# UNITED STATES PATENT AND TRADEMARK OFFICE

APPLICATION NO.	FILING DATE	FIRST NAMED INVENTOR	ATTORNEY DOCKET NO.	CONFIRMATION NO.
10/014,227	12/11/2001	Benoit R. Veillette	US010594	3093

**Office Action Summary**

## **DETAILED ACTION**

FIG. 1

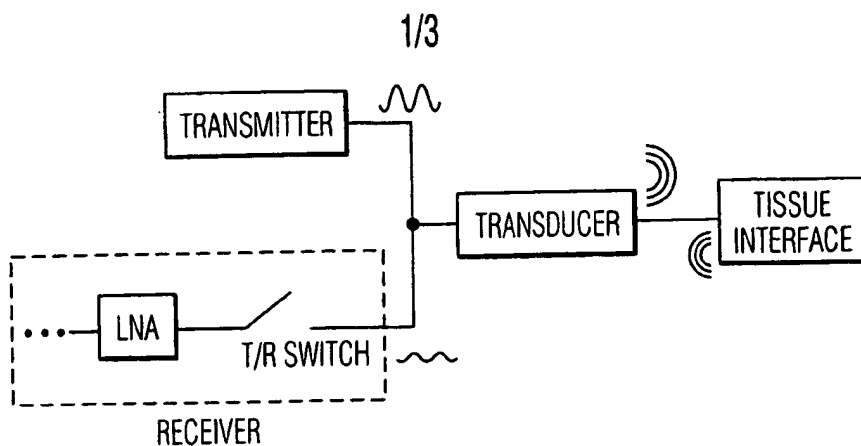
1. Figures 1-5 should be designated by a legend such as --Prior Art-- because only that which is old is illustrated. See MPEP § 608.02(g). Corrected drawings in compliance with 37 CFR 1.121(d) are required in reply to the Office action to avoid abandonment of the application. The replacement sheet(s) should be labeled "Replacement Sheet" in the page header (as per 37 CFR 1.84(c)) so as not to obstruct any portion of the drawing figures. If the changes are not accepted by the examiner, the applicant will be notified and informed of any required corrective action in the next Office action. The objection to the drawings will not be held in abeyance.

Regarding claim 1. Applicants openly admit that prior art teaches a receiver circuit (see RECEIVER in figure 1), comprising:

a switch for blocking high voltages and for converting voltage signals to current signals (see T/R switch in figure 1), said switch comprising first and second signal terminals (see conventional T/R switch depicted in figure 4B wherein first terminal is labeled as 405 and second terminal labeled as 410) and a control terminal (see control terminal labeled as 400 figure 4B) said switching exhibiting an ON resistance when closed, said ON resistance controlled by an electric value at said control terminal;

Regarding claim 2. Applicants openly admit that prior art already teaches T/R switch (see T/R SWITCH in figure 1) used to couple transducer (see TRANSDUCER figure 1) and low-noise amplifier (see LNA coupled to other side of T/R switch in figure 1).

Regarding claim 14. Applicants openly admit that prior art already teaches T/R switch (see T/R SWITCH in figure 1) used to couple transducer (see TRANSDUCER figure 1) and low-noise amplifier (see LNA coupled to other side of T/R switch in figure 1).

FIG. 4A

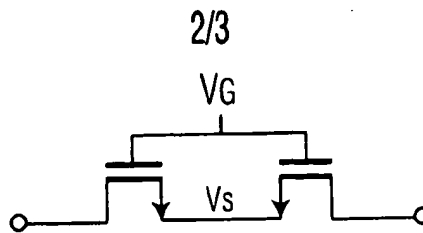
a control circuit coupled to said switch for controlling said ON resistance of said switch in closed position (see figure 4A and Applicants admitted prior art at top of page 4 in Applicants specification wherein control circuit shown used to control resistance of T/R switch shown in figure 4B).

resistance when closed, said ON resistance controlled by an electric value at said control terminal, the receiver circuit further comprising a control circuit coupled to said switch for controlling said ON resistance of said switch in closed position (see figure 4A and Applicants admitted prior art at top of page 4 in Applicants specification wherein control circuit shown used to control resistance of T/R switch shown in figure 4B).

FIG. 5

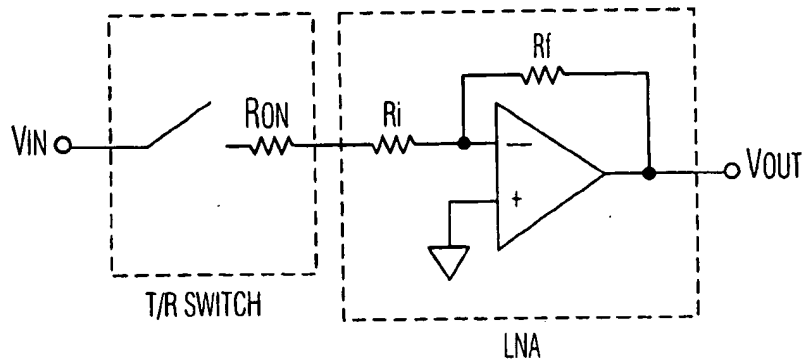
Regarding claim 4. Applicants admit that receiver circuit of claim 2 wherein low-noise amplifier circuit requires an input resistance (see  $R_i$  for LNA circuit shown in prior art figure 5) and a feedback resistance (see  $R_F$  for LNA circuit shown in prior art figure 5), and further wherein on resistance of switch is input resistance of said low-noise amplifier circuit (see  $R_O$  of switch inputted to resistance of LNA figure 5).

a low-noise amplifier (see LNA of admitted prior art figure 5) for amplifying low-voltage pulses while minimizing electronic noise, said amplifier circuit requiring an input resistance (see  $R_i$  figure 5) and feedback resistance (see  $R_f$  figure 5), wherein said input resistance is said ON resistance of said T/R switch (see figure 5 wherein  $R_{on}$  of switch must match input impedance of LNA).

Regarding claim 16. Applicants admit that receiver circuit of claim 2 wherein low-noise amplifier circuit requires an input resistance (see  $R_i$  for LNA circuit shown in prior art figure 5) and a feedback resistance (see  $R_F$  for LNA circuit shown in prior art figure 5), and further wherein on resistance of switch is input resistance of said low-noise amplifier circuit (see  $R_O$  of switch inputted to resistance of LNA figure 5).

FIG. 7

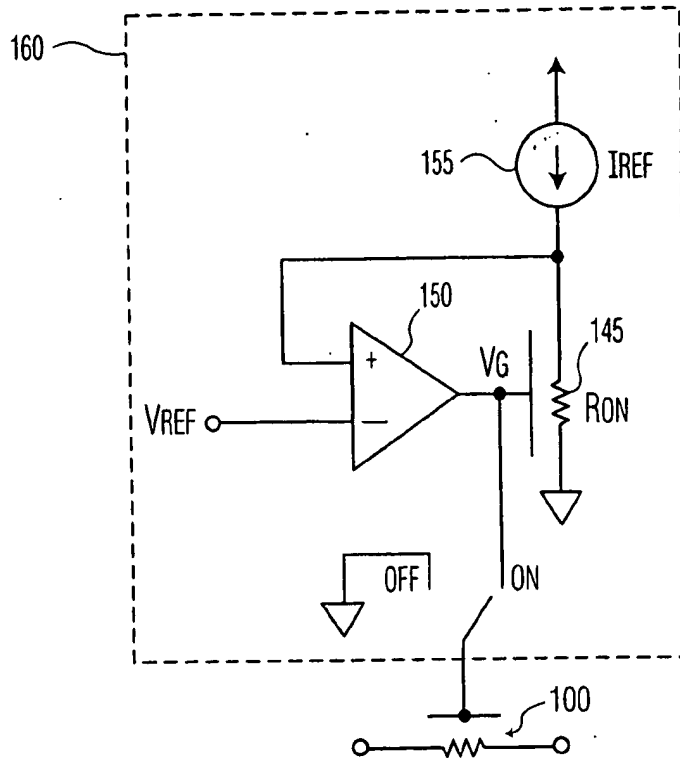
Regarding claims 5-7, 10-12 and 17-19. Applicants admit that prior art (see figures 1-5) fail to show a servo-loop depicted in figure 7.
